**OFFICE OF THE PRINCIPLE CHIEF CONSERVATOR OF FOREST, HOFF,
RAJASTHAN, JAIPUR**

CCF resubmitted the proposal after amendment corrections. User Agency submits digital maps of the proposal FP/RJ/Road/6999/2014 as per required by MOEF & CC for their letter no.8B/Raj/06/5/2015/FC/For-04 dated 5.04.2016. After examination of digital maps some query in the submitted digital maps.

Sheet No 1

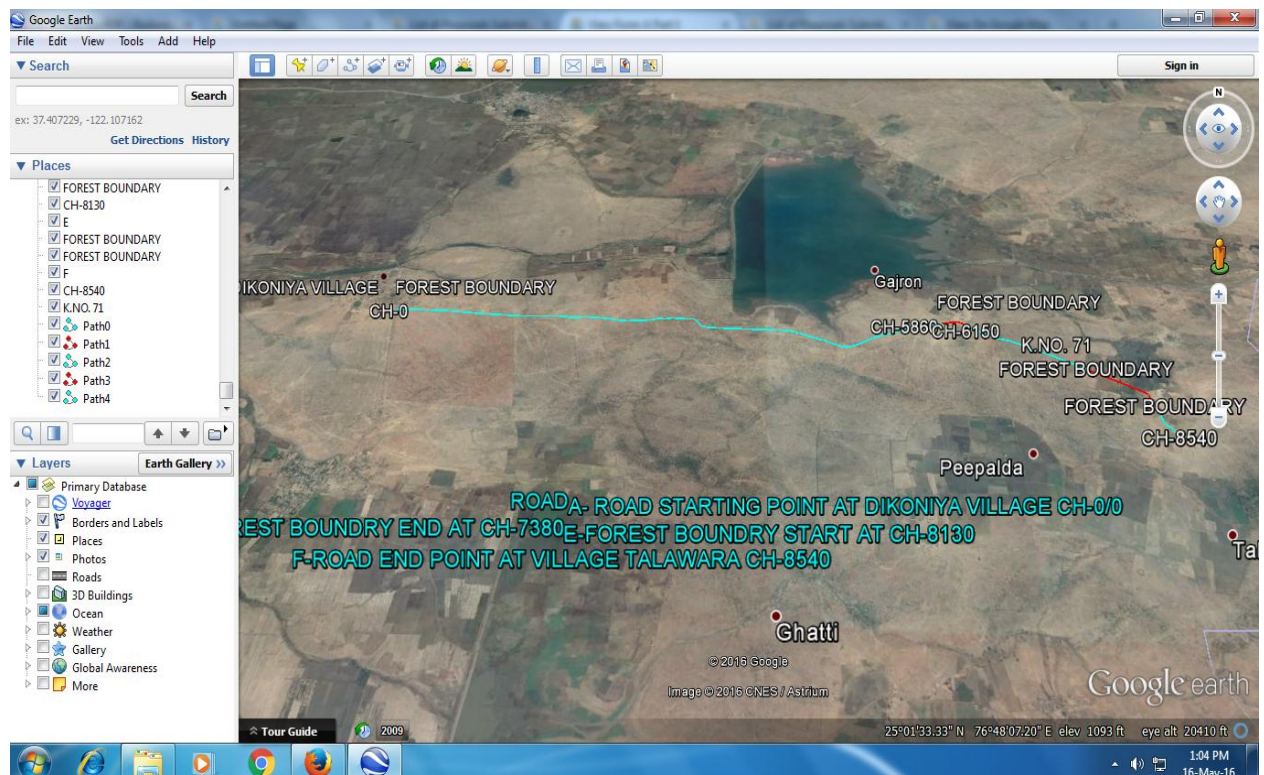
1. Digital Maps are in line shape while MOEF &CC required in polygon shape for DSS analysis.
 2. Sheet No 1 expressed that provided digital maps are prepared in path. Total path are 5.
 3. Sheet no 2 expressed that provided digital maps are in line shape.
 4. Sheet No 3 expressed that provided digital maps have a length of 11776 meter in forest while the length of road in forest is only 7500 meter.
- Hence, Digital maps are not satisfactory, the proposal is to be forwarded to CCF for modify/ revised digital maps.
